# **Staff Report**

Re: PLNPCM2022-01149 Conditional Use Permit for ADU at 1005 Princeton Ave

# ADU @ 1005 PRINCETON AVE.

A606

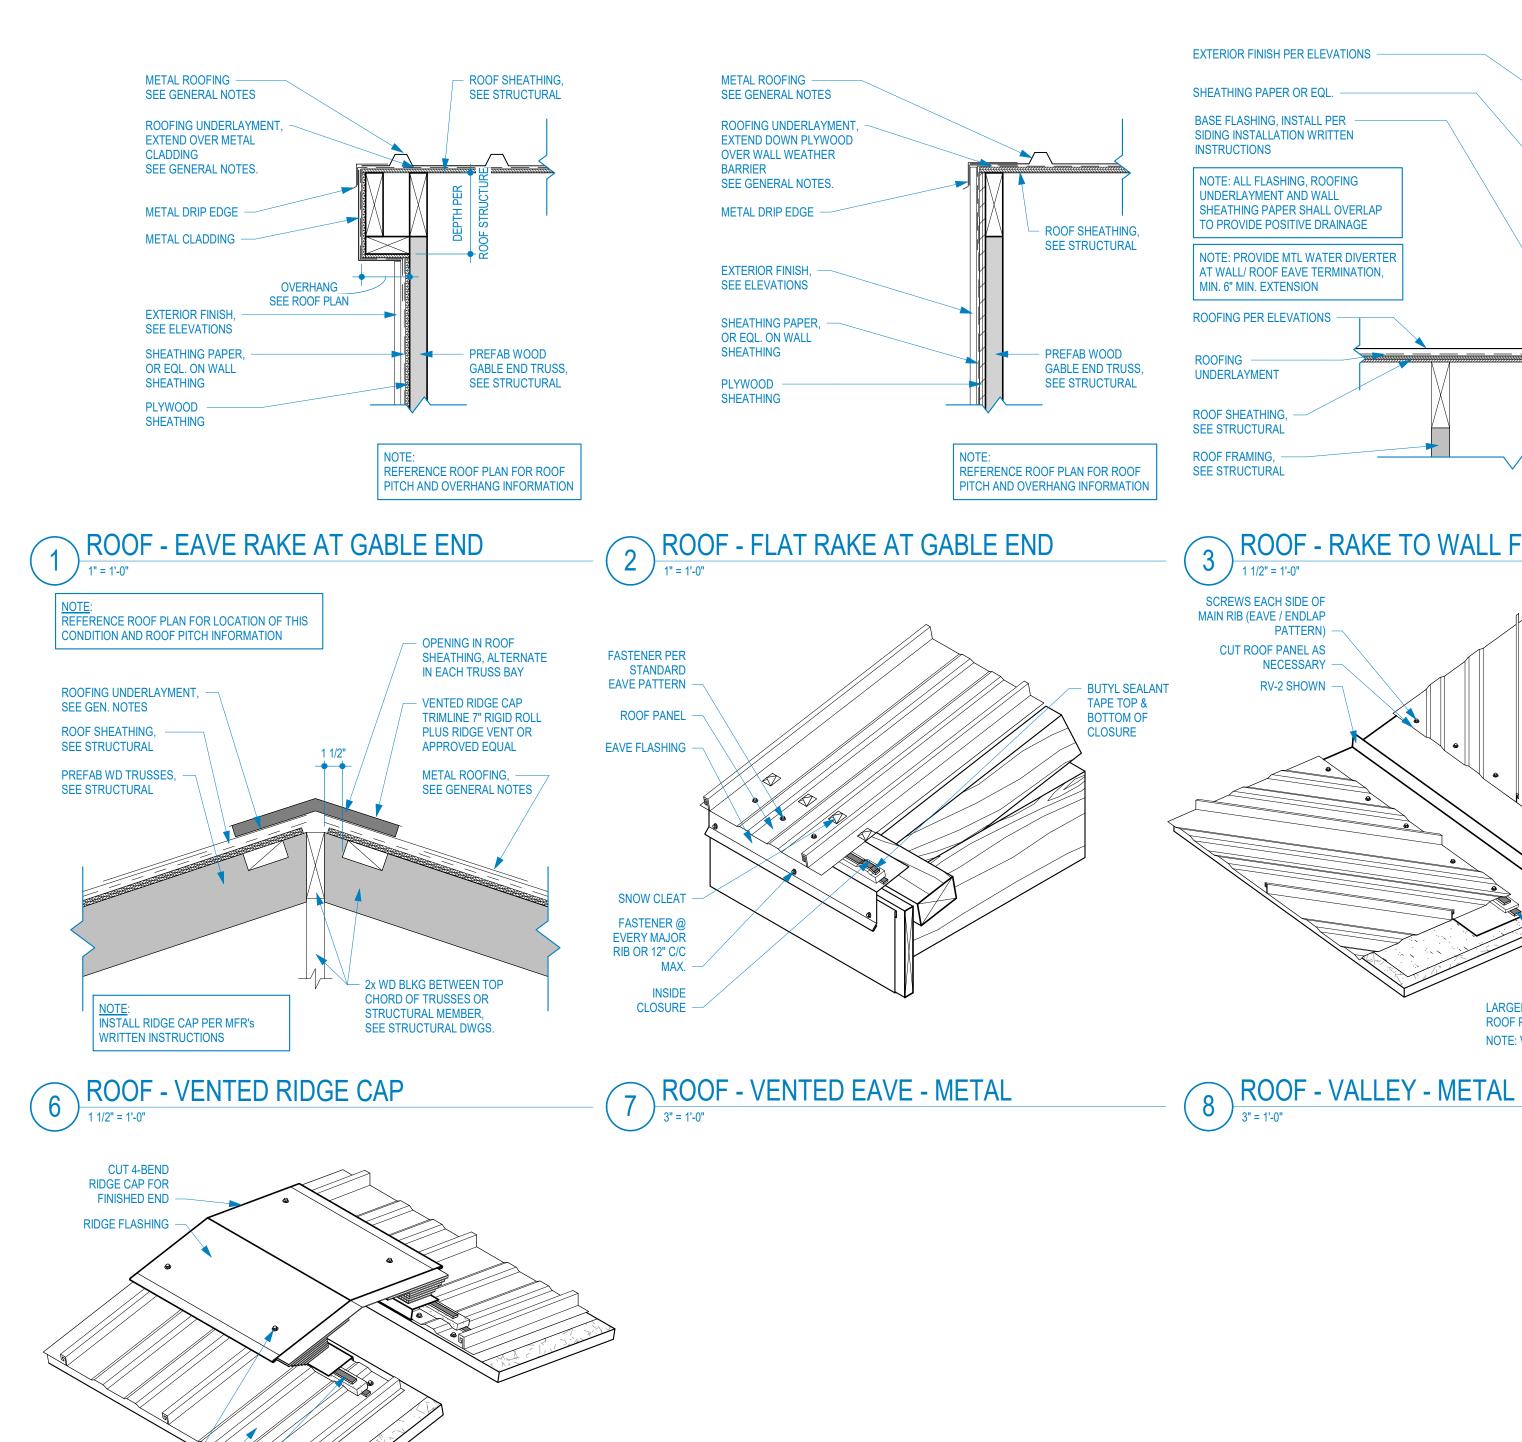
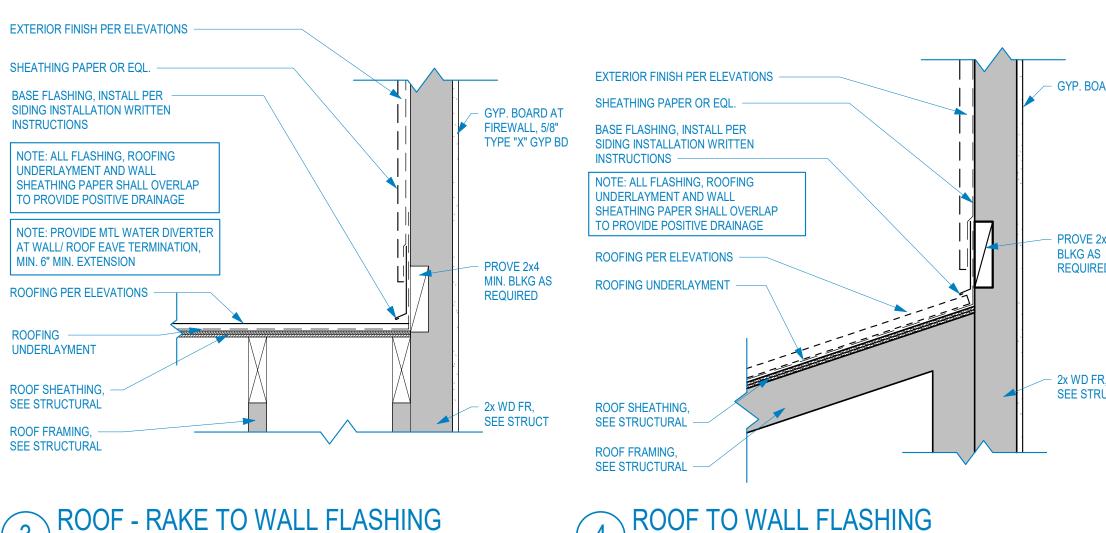
IRC 2015 with State amendment criteria/// Plans subject to full building Code Review/// Fire separations in garage to upper habitable spaces & within 5ft of property lines. Plan A606 Detail 10 Entry stair is concerning with the open and unprotected fall/trip hazard of the rise of the stair assembly
